Statement of Environmental Effects

Ivanhoe Estate
Section 4.55(1A) Modification Application

Submitted to Department of Planning, Industry
and Environment
On behalf of Frasers Property Australia

11 March 2021 | 17156

Figure 6 Approved Level 5-12 Plan

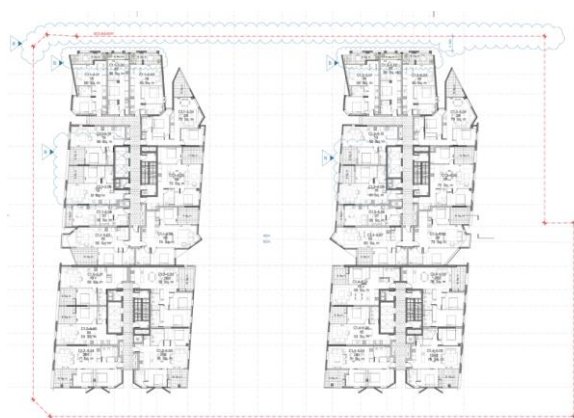
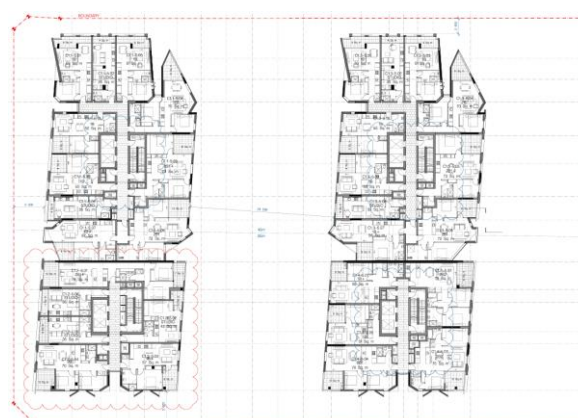
The provision of affordable housing dwellings have been achieved through the reduction of market dwellings and the reconfiguration of the internal building layout to Building C1.2. The provision of affordable housing dwellings has had the effect of revising the approved apartment mix however will not materially alter the approved building envelope and will ultimately result in the reduction of gross floor area in the order of 116m².

Figures 5 to 8 depicts the approved and proposed floor plans from Architectural Plans prepared by Candalepas and Associates.

**Figure 8 Approved Basement Level 3 Plan**

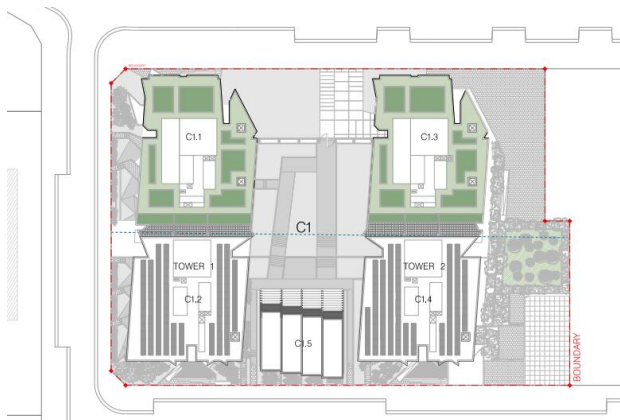
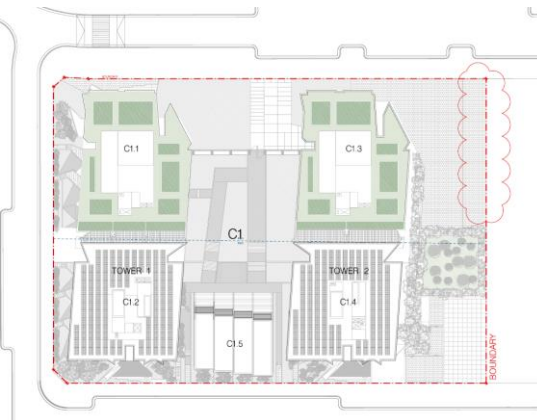
The basement design and car parking provision has been amended to account for the changes to the housing tenure of Building C1 and to facilitate car parking for the future community centre, pool and gym facilities in addition to car share spaces as required by the Concept Plan and Stage 1 consent. In total, the car park provision has been summarised in **Table 1**.

The layout of the car park has been amended to enhance circulation including the provision of a direct ramp from ground level to Basement Level 3 for car parking associated with the future community centre. This enables patrons of the community centre to access parking without traversing the residential car park. Other refinements to the basement design have also been incorporated to improve access and circulation. **Figures 9 and 10** depict the approved and proposed Basement Level 3 Plan from the Architectural Plans prepared by Candalepas and Associates.
